## **A38 Derby Junctions**

**TR010022**

### **8.59 Technical Note on Markeaton Junction Northbound Diverge Slip Road – Access to Euro Garages and McDonald's**

**Technical Note on Markeaton Junction Northbound Diverge Slip Road –  
Access to Euro Garages and McDonald's**

### Entry/Egress with A38 NB Diverge Slip road Sketch

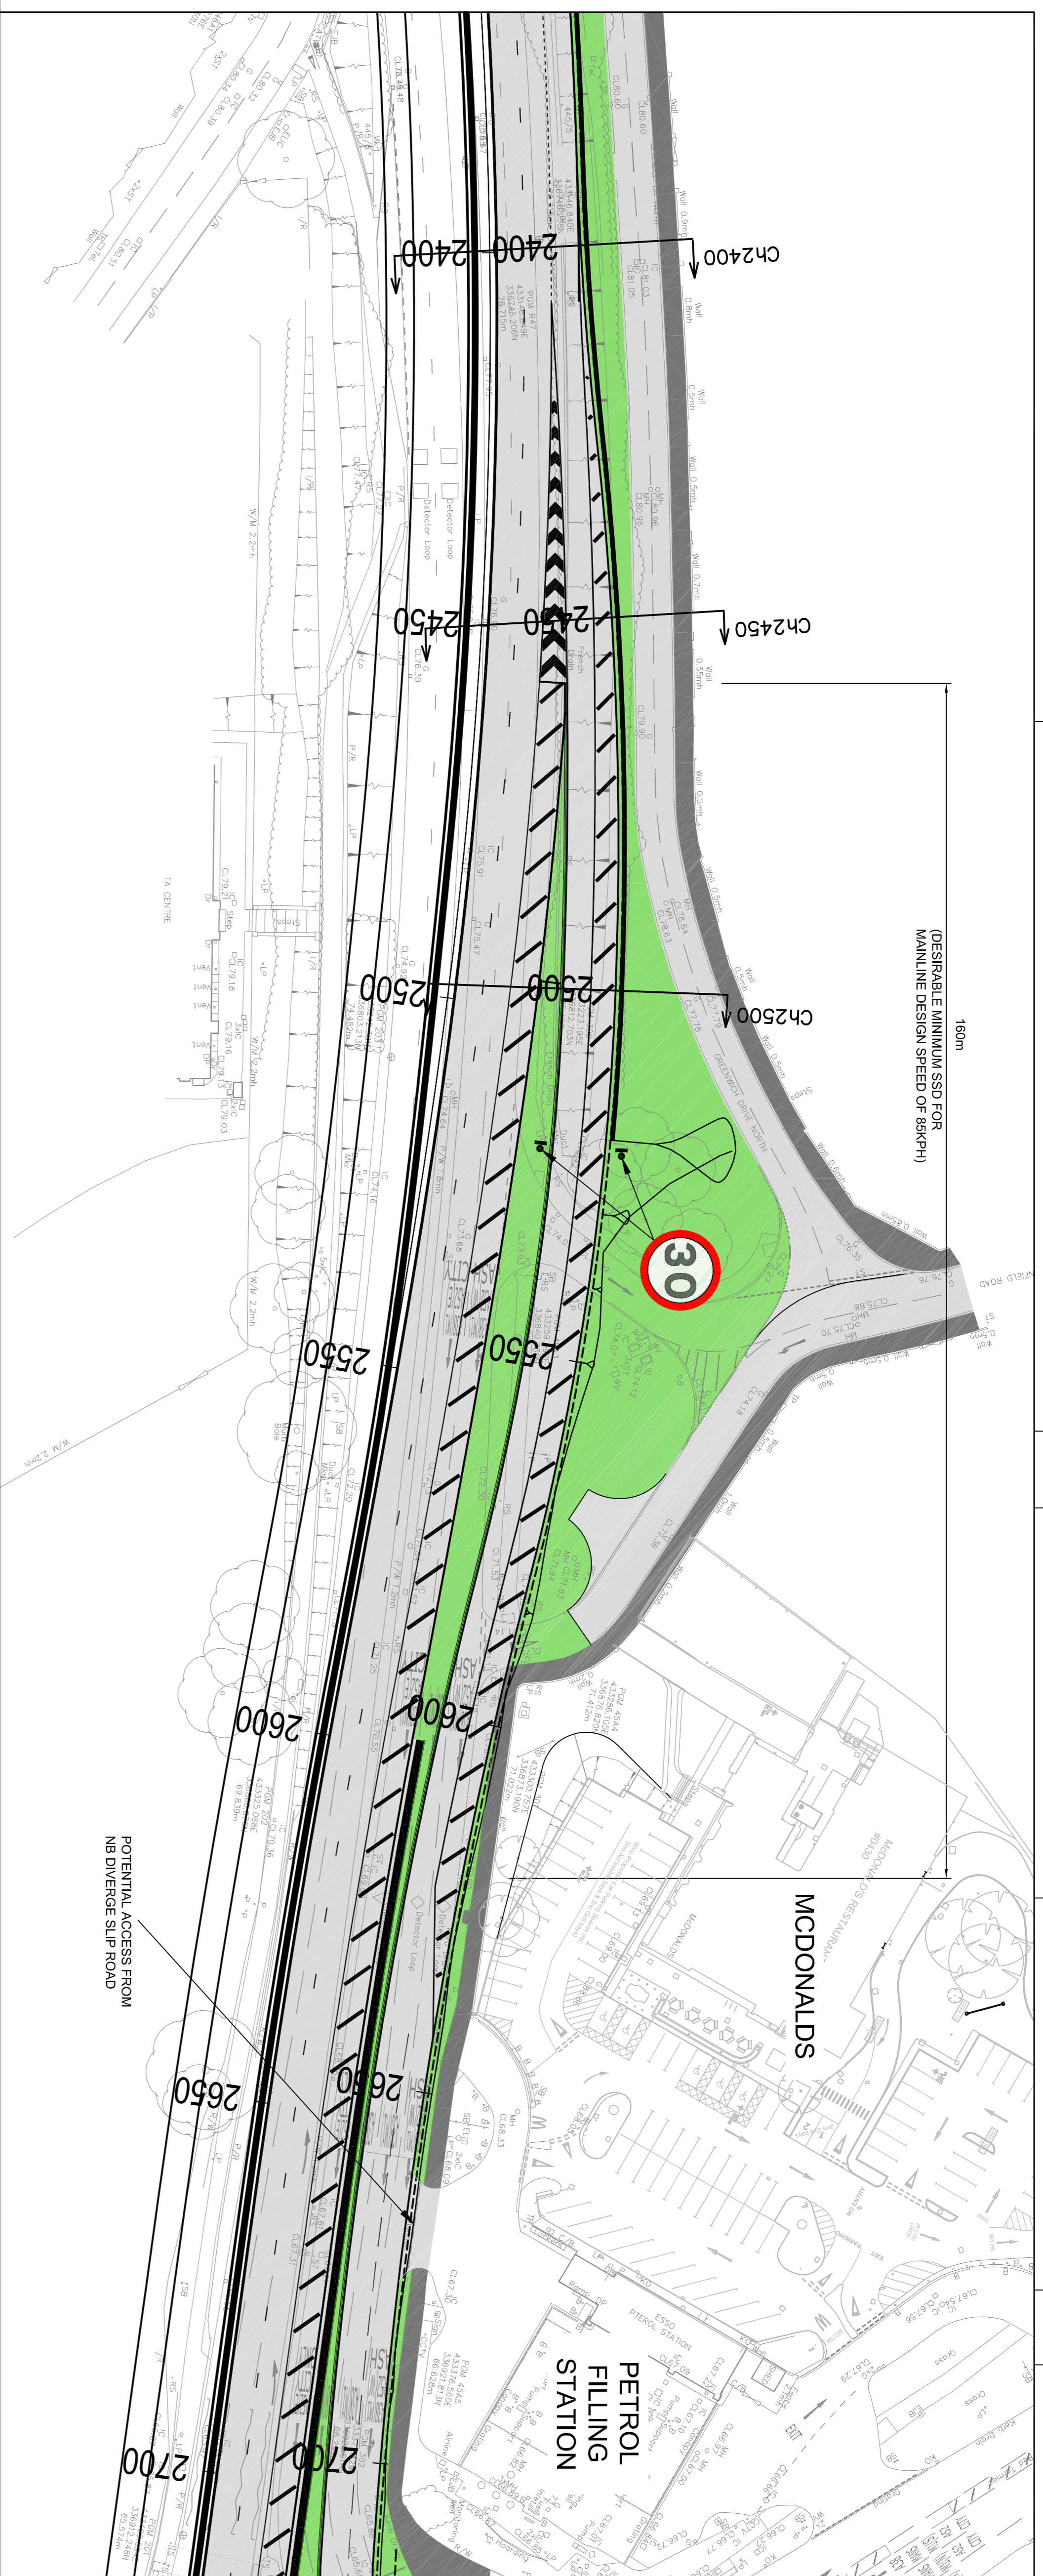
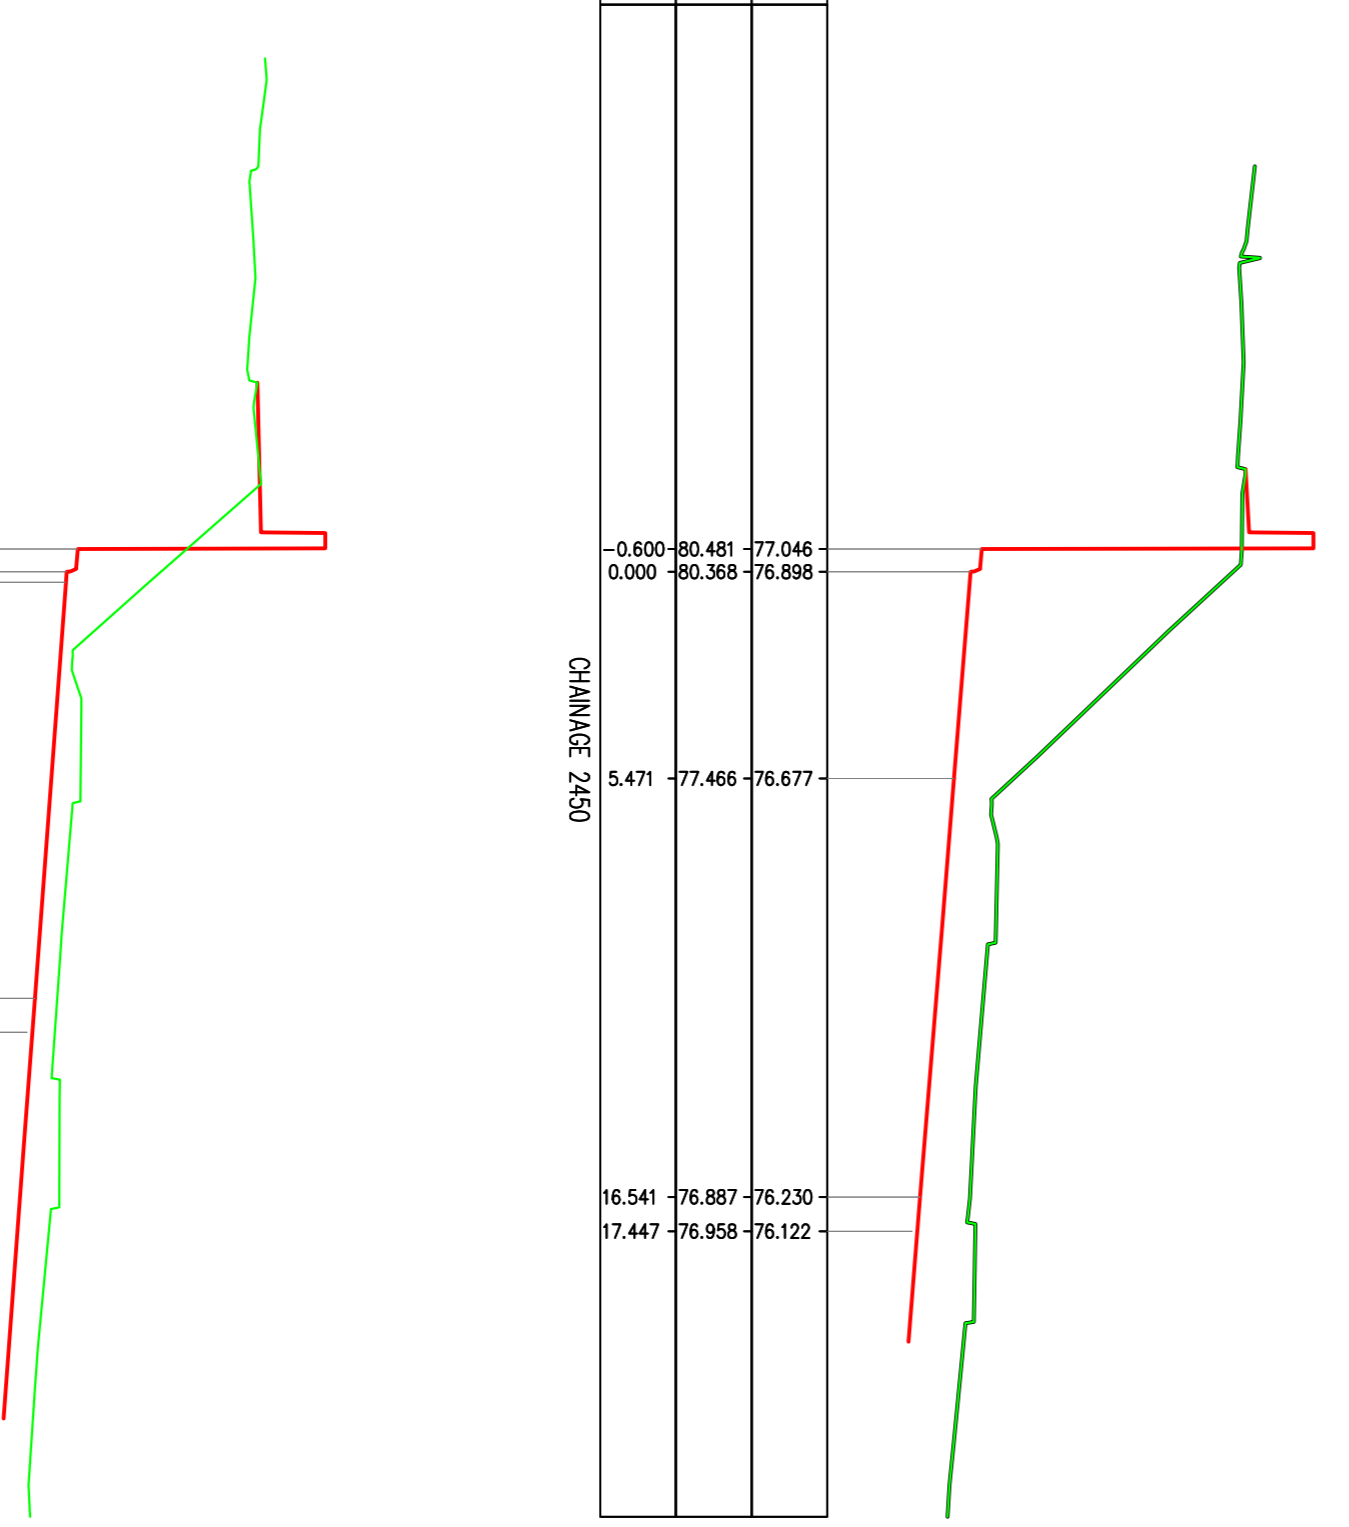
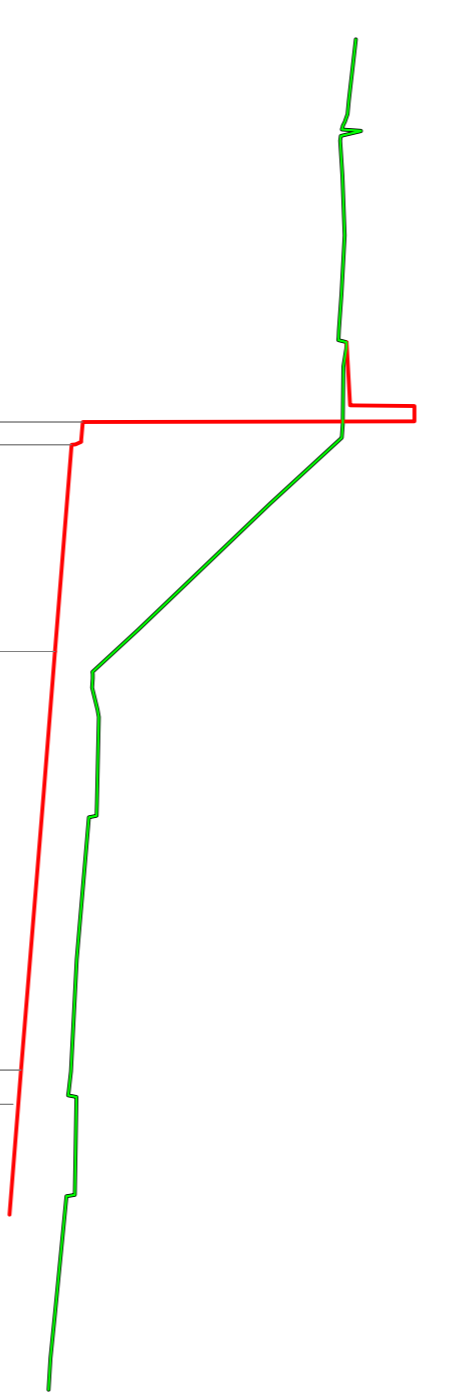
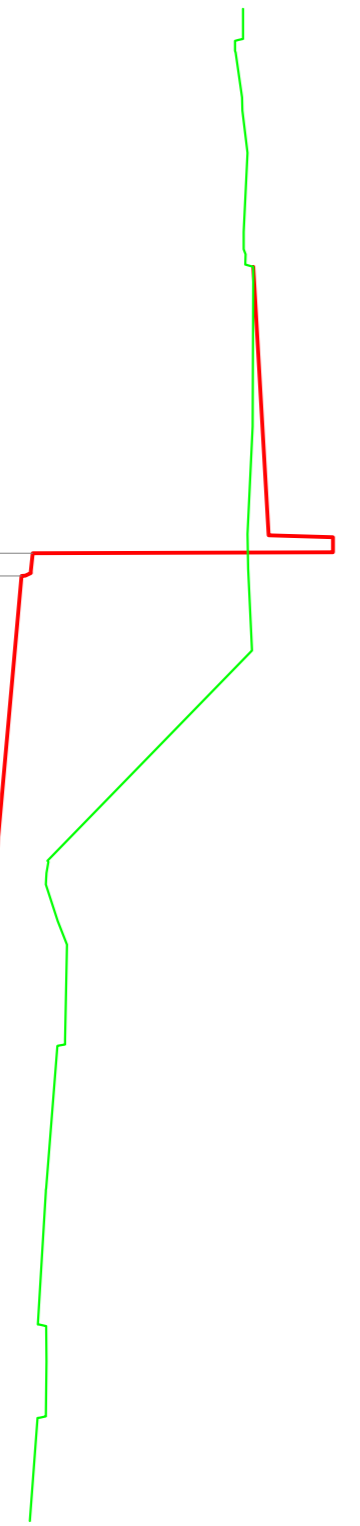
- 
- 4.10 The following summarises the response received following issue of the above to HE SES (SR-D)
- 4.11 Quoting SR-D's email "*Given the level of road user risk associated with the proposed layout (option 7), the fact that there are viable alternatives and the suggested claims are unlikely to be realistic, the 'preferred option' would not meet the basic criteria for DfS approval. If approval was granted, we [Highways England] would not be able to provide a reasonable defence to our decision-making process in the event that it was questioned in a Coroner's Court. Under the Construction (Design and Management) Regulations 2015, the designer has a duty to eliminate foreseeable health and safety risks where reasonably practicable. If we choose to not eliminate such a hazard, then we could be seen to have failed to meet our legal obligations.*

- To conclude, I can confirm that SR-D do not support the preferred option. I appreciate this isn't the answer you were hoping for; however, Highways England's number one imperative is safety and agreement to the proposed layout would mean other factors would be placed above this.*

- Access from the slip road only is an option that we are open to; however, I must stress given the position we are in that in order for this to be approvable it must be possible to demonstrate that the resultant layout represents the best overall option when weighed up against the alternatives. It must also not include an intolerable level of residual risk. While identification of the scale and nature of action required to support a particular development is the responsibility of the development promoter."*

- 4.12 A further meeting with HE SR-D was held in June 2018 to discuss the situation. At the meeting, SES confirmed they were still not prepared to accept an access/egress arrangement with the A38 slip road. They would like to see a sketch showing one-way (access or egress) solution onto the A38 slip road, (egress only onto slip road was progressed as this provides an easier access for A52 traffic and southbound A38 traffic).
